MAYOR AND COUNCIL OF THE TOWN OF WINDERMERE

January 24, 2023

Re: Third Town Council Workshop Windermere Downtown PUD Final Engineering Plan

WINDERMERE
DOWNTOWN
PROPERTY

WINDERMERE DOWNTOWN WALL RENDERING - 10/27/2022

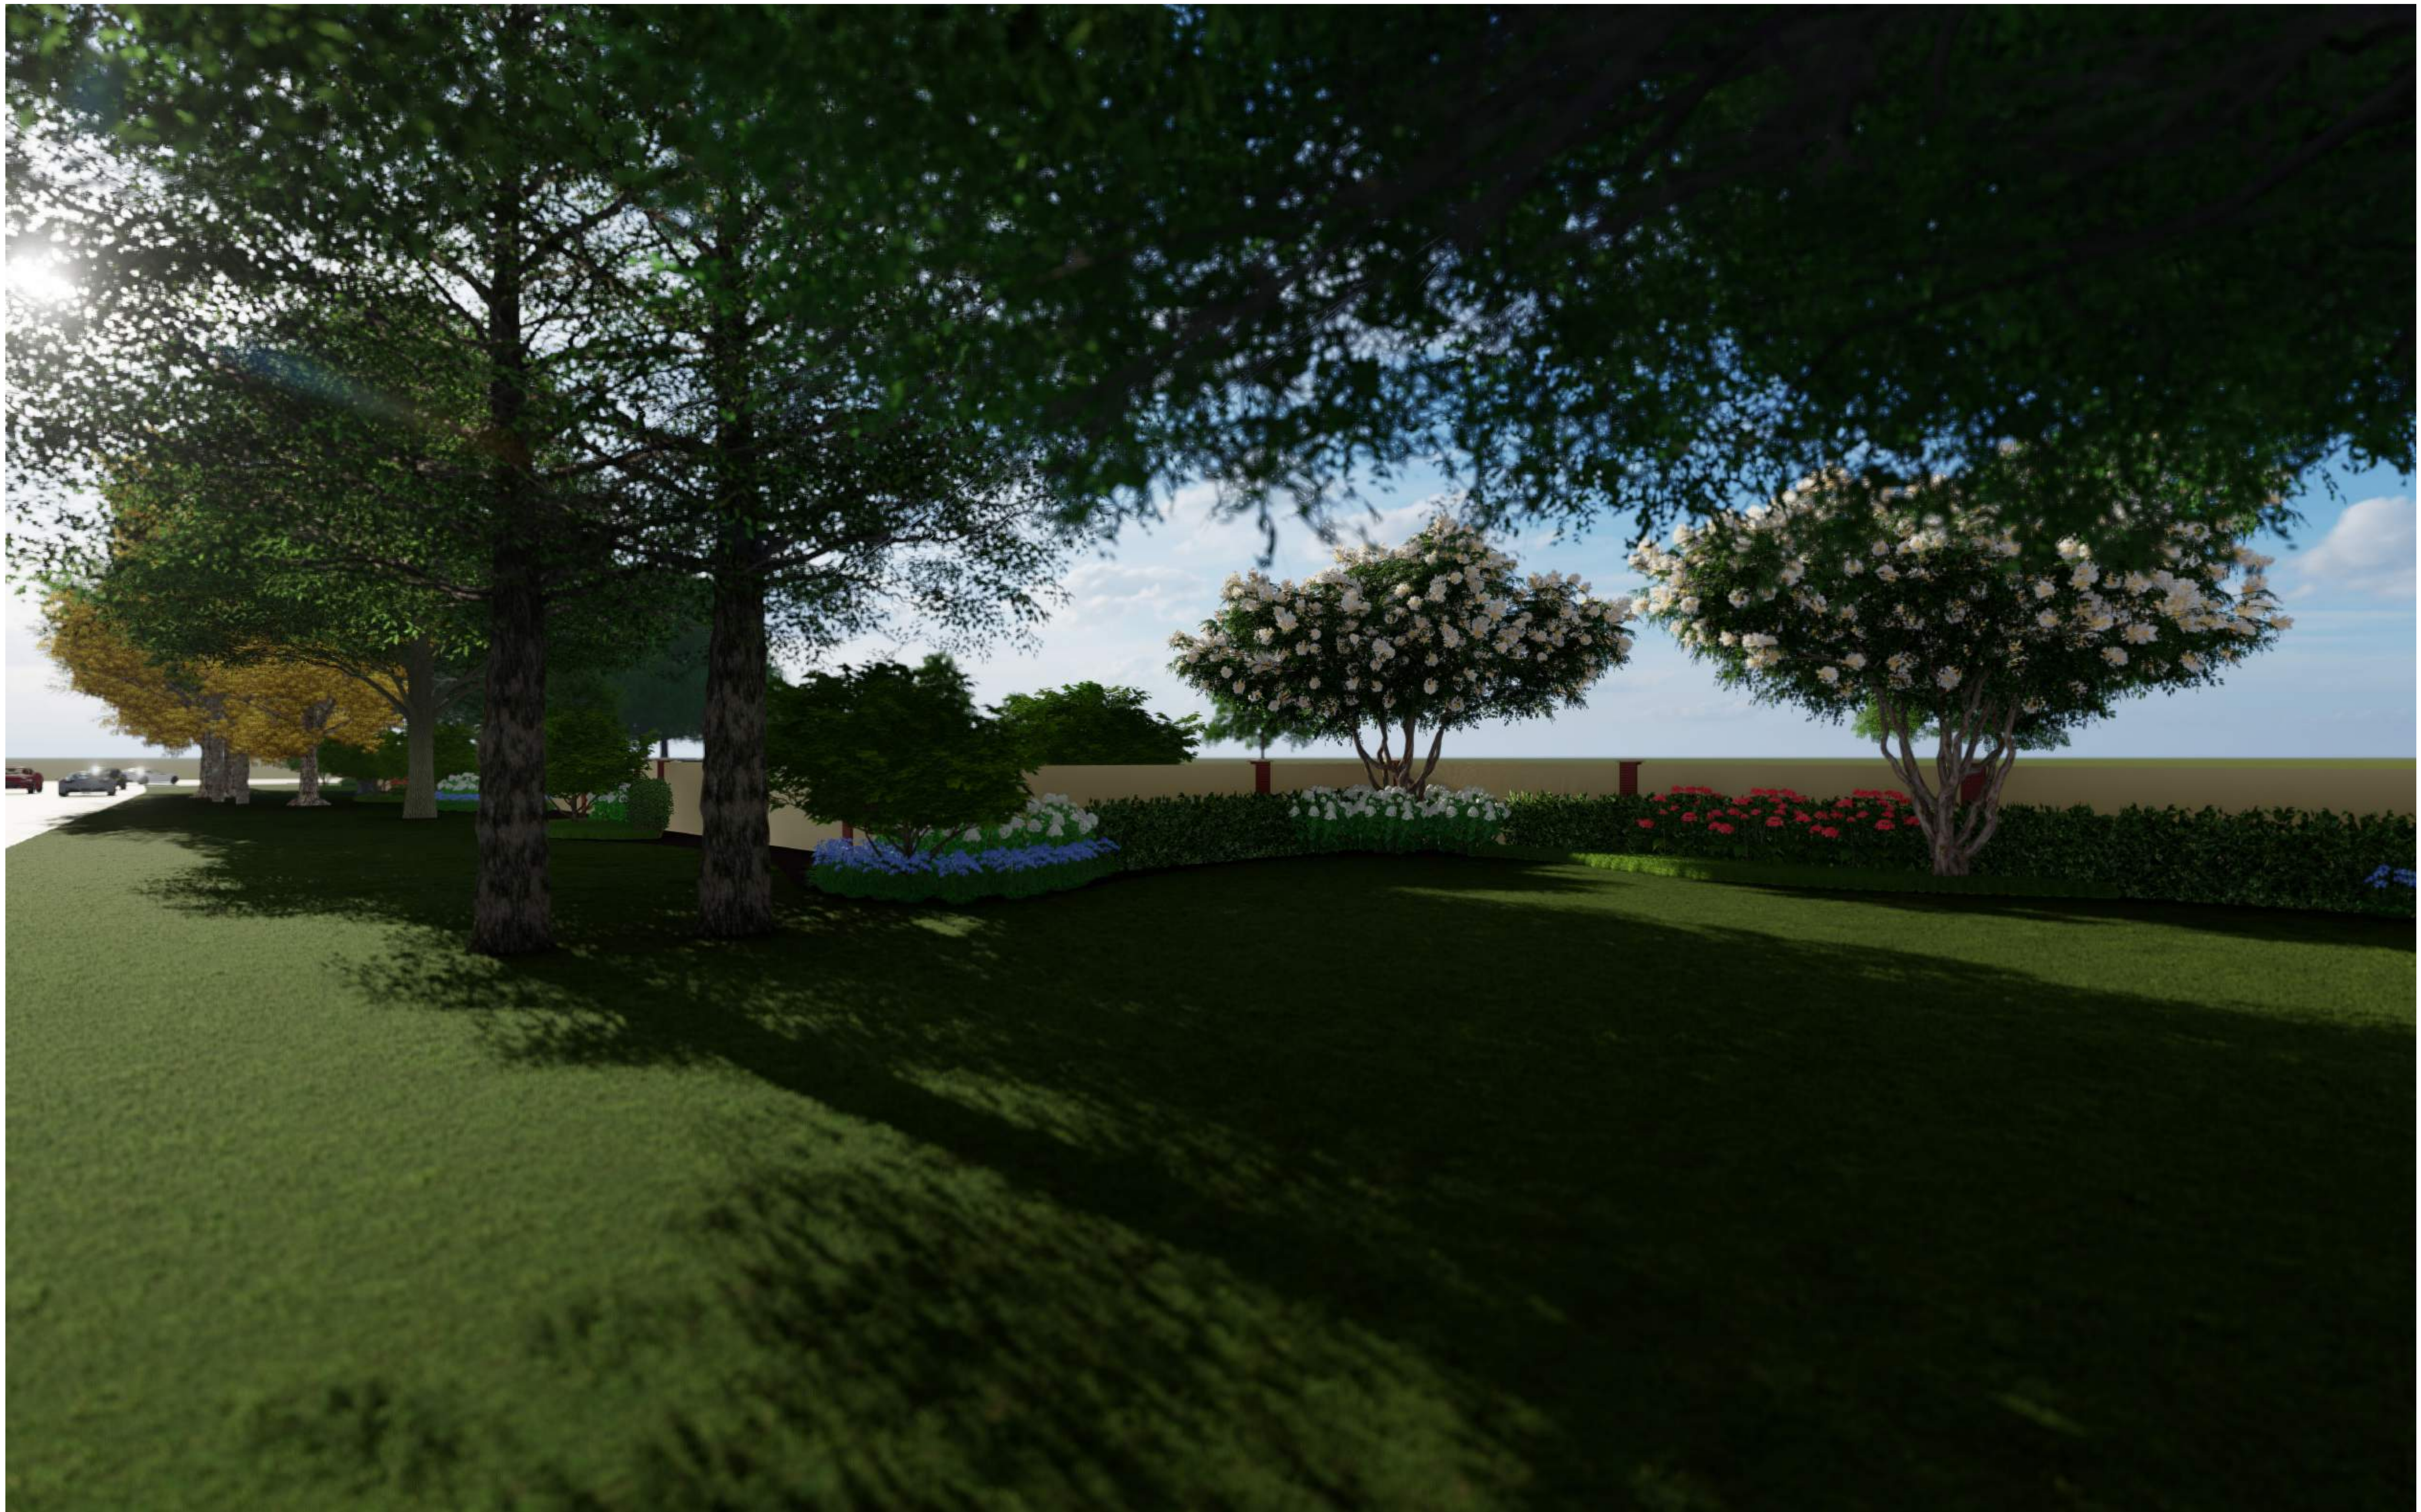
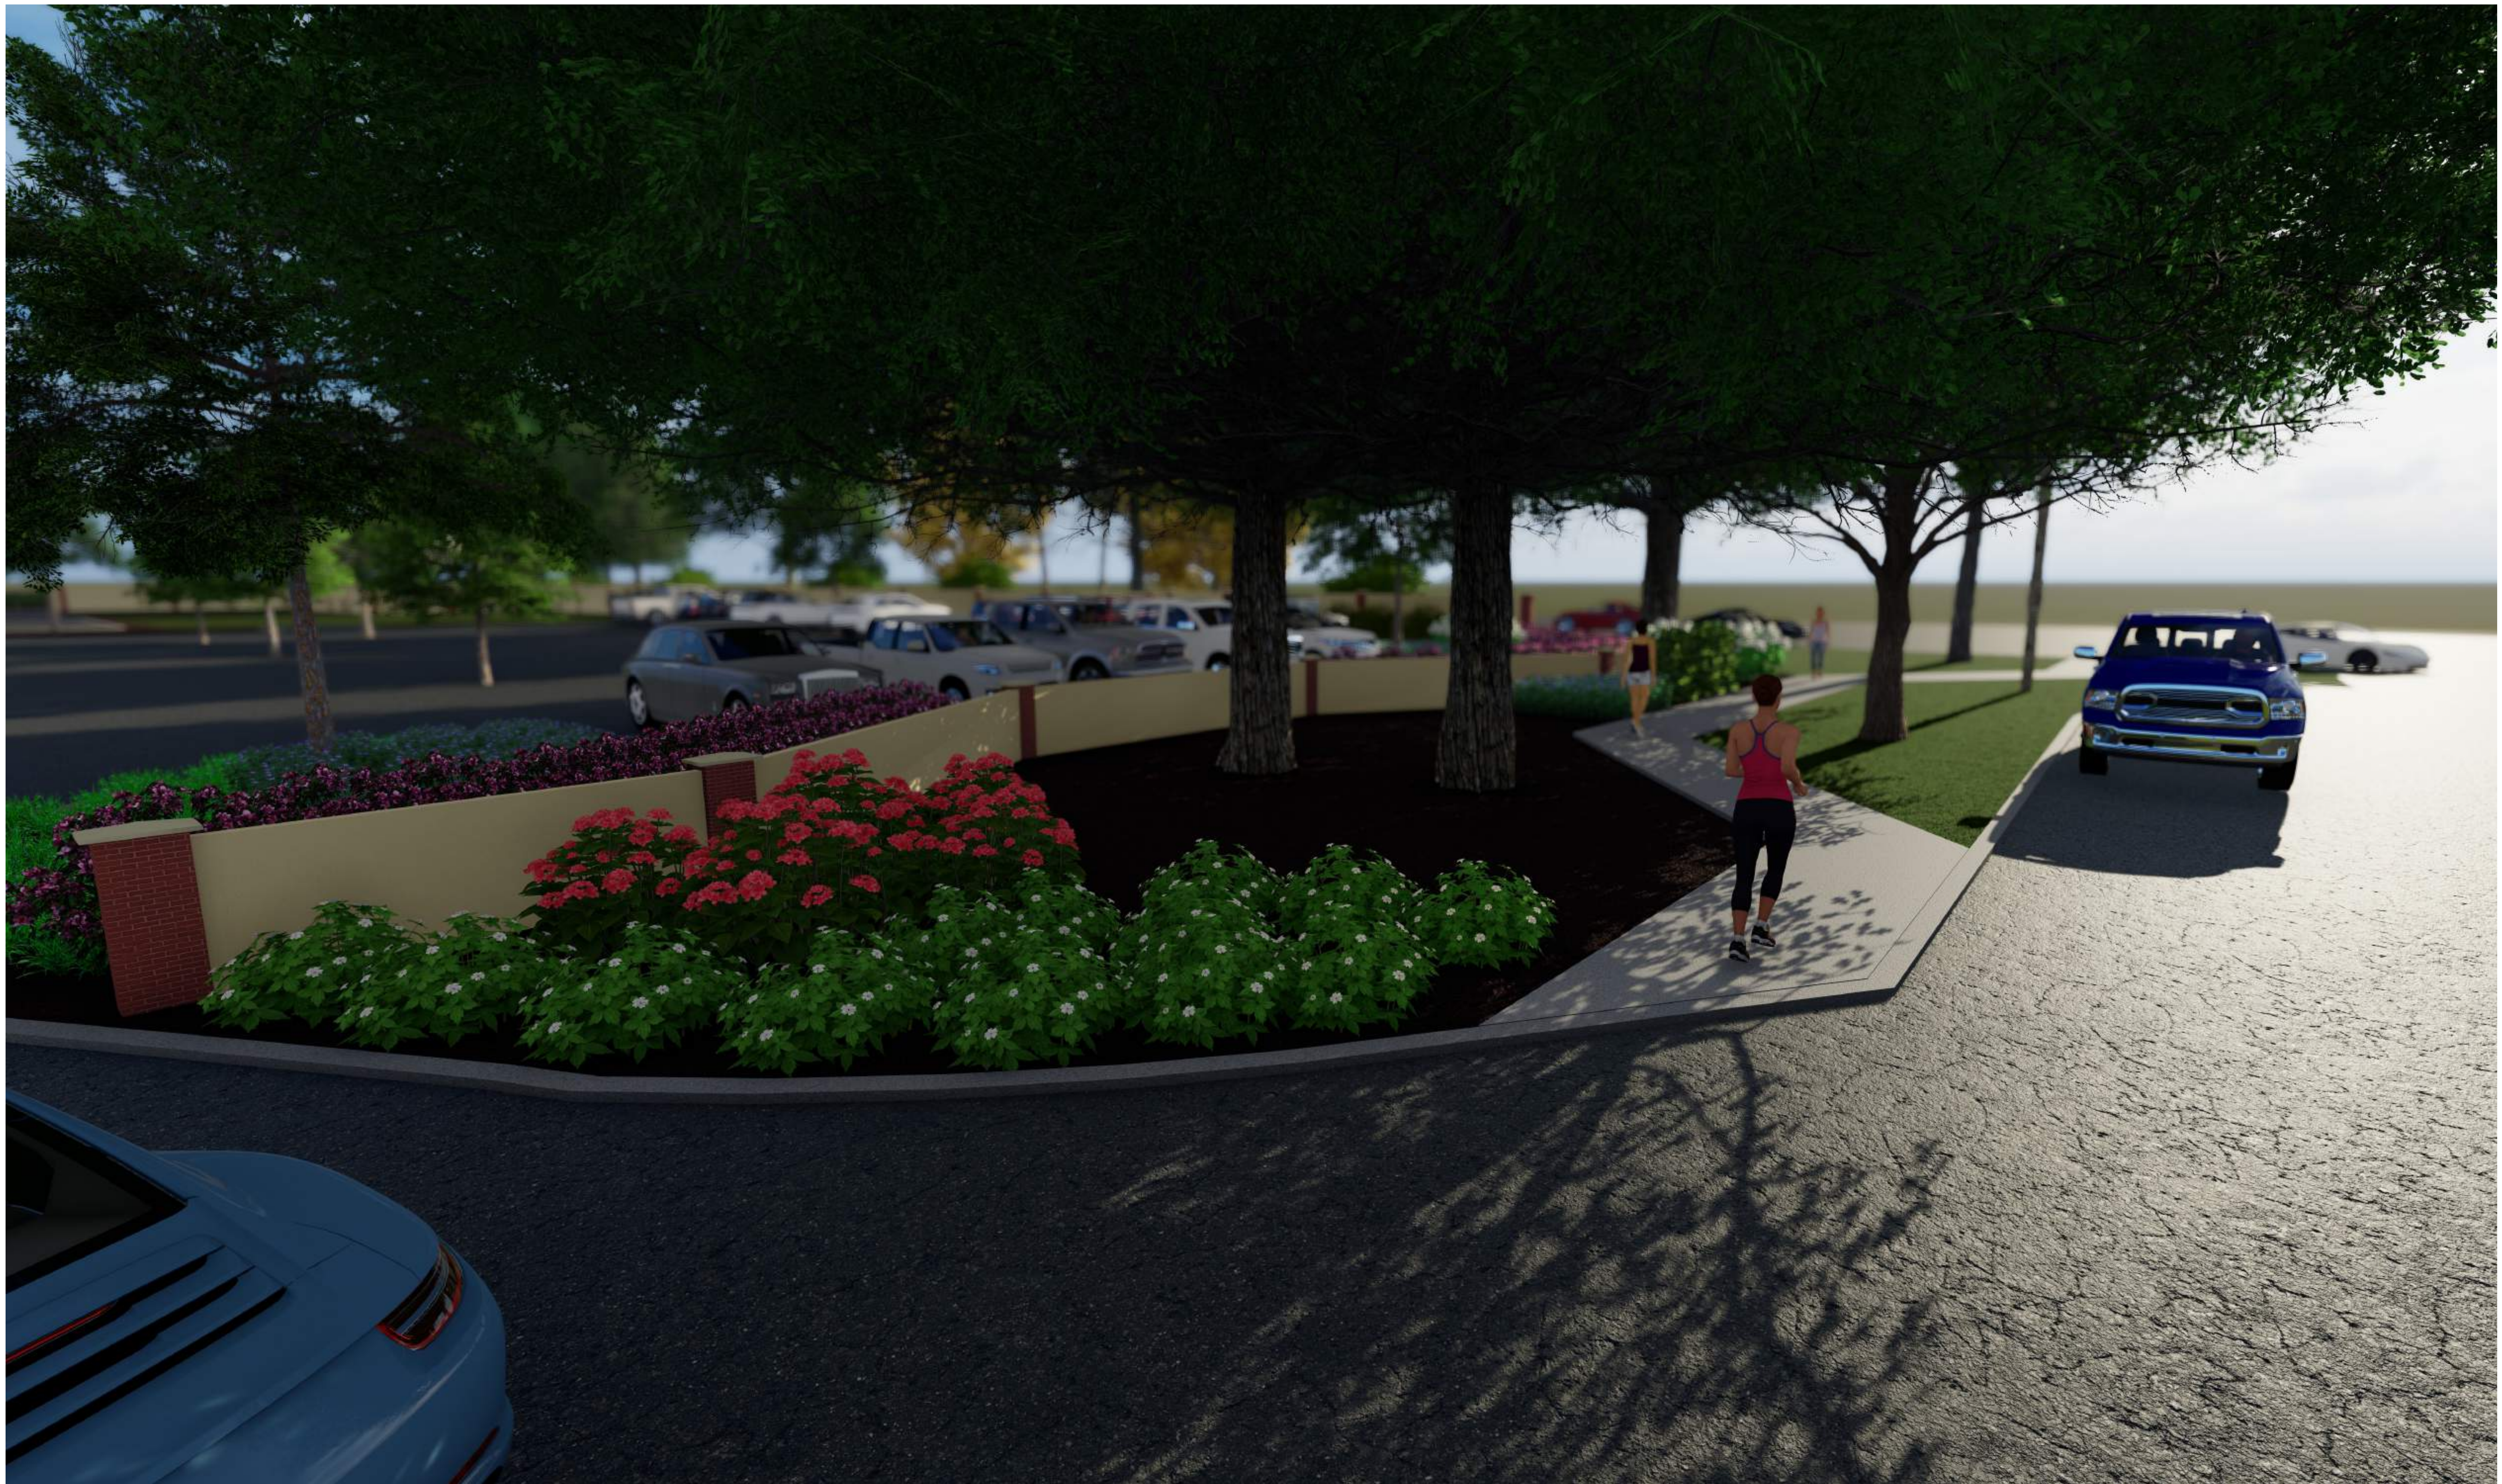
4. The renderings submitted for the buffer wall and landscape give me great concern. The renderings have no connection or relationship to the existing conditions of the area. The renderings appear that there is a parking lot in a middle of a grass field somewhere in the mid-west with no other buildings or other development. Even with my extensive time working with the Town, it is extremely difficult to determine the relationship of the renderings to reality. Another item that gives me concern is that the roads and parking appear to be paved with asphalt. I know that is not the intent; however, that is what is shown on the renderings and can be easily misunderstood. The renderings provided for the buildings are more appropriate as they provide the context of the existing conditions. The renderings for the buffer wall and landscaping should provide that same context to appropriately and correctly relate to the existing conditions. This is not a requirement of the Town's Land Development Code or PUD; however, presenting renderings that are not correct and misrepresent the context are not supportive of a positive response to the plans. Here is an example. According to its title, this submitted rendering is the corner of E 6th Avenue and Oakdale Street:

This rendering appears to be somewhere other than in the Town of Windermere and certainly not in the middle of the Town. Renderings should give context to communicate the expected outcome of the improvements related to the area where it is placed. In my opinion, the submitted buffer wall and landscape renderings only add confusion and misunderstanding about the intent of the project and

buffer wall and landscaping.

- The concerns on the provided renderings, we are willing to have these pulled from the package if it is causing any confusion. These renderings were completed and provided for illustrative purposes to show how the wall would interact with the site. These were not provided to depict a detailed view of each viewpoint of the site.
- The wall heights provided are based on input from the 2 previous workshops and the original PD requirements. If the request is to keep the wall per what's already detailed in the PD we will keep it as a 6-ft wall in all areas.
- The sign bands shown in the elevations are for location indication only. For final design, we will be adhering to the Town's signage criteria.
